CATCHMENT DITCH DETAILS

KAILUA ROAD PERMANENT ROCKFALL AND LANDSLIDE MITIGATION PROJECT NO. 61D-02-06

ADD. 21

1/21 TYPICAL CATCHMENT DITCH

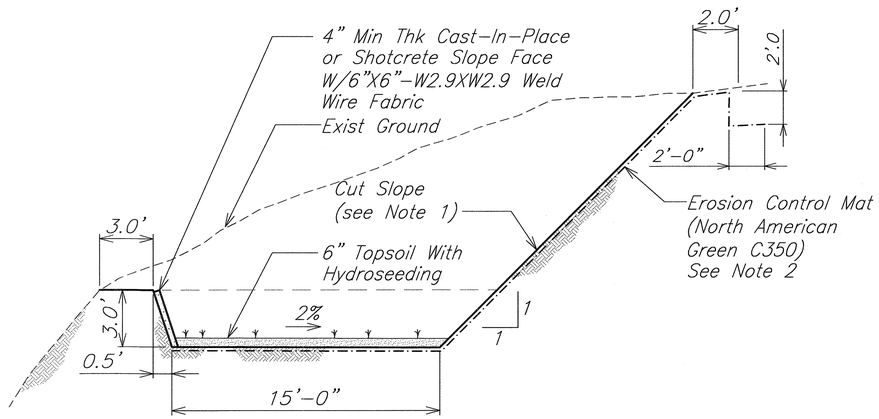
Date	Revision
9/11/06	Added Note 3 to Detail 1/21; revised elevation on Detail 2/21

1. Max Cut Slope Shall be 1H:1V. Actual Slope Construction and/or Structural Supported Slope Design, If Required, Shall be Determined In the Field by the Geotechnical Engineer.
2. Where Rock Surface is Encountered, Erosion Control Mat Shall be Secured using Proper Anchor Bolts.
3. Cost of Welded Wire Fabric shall be considered incidental and included in the lump sum amount bid under Proposal Item 503.0500 – Concrete for Rockfall Catchment Ditch.
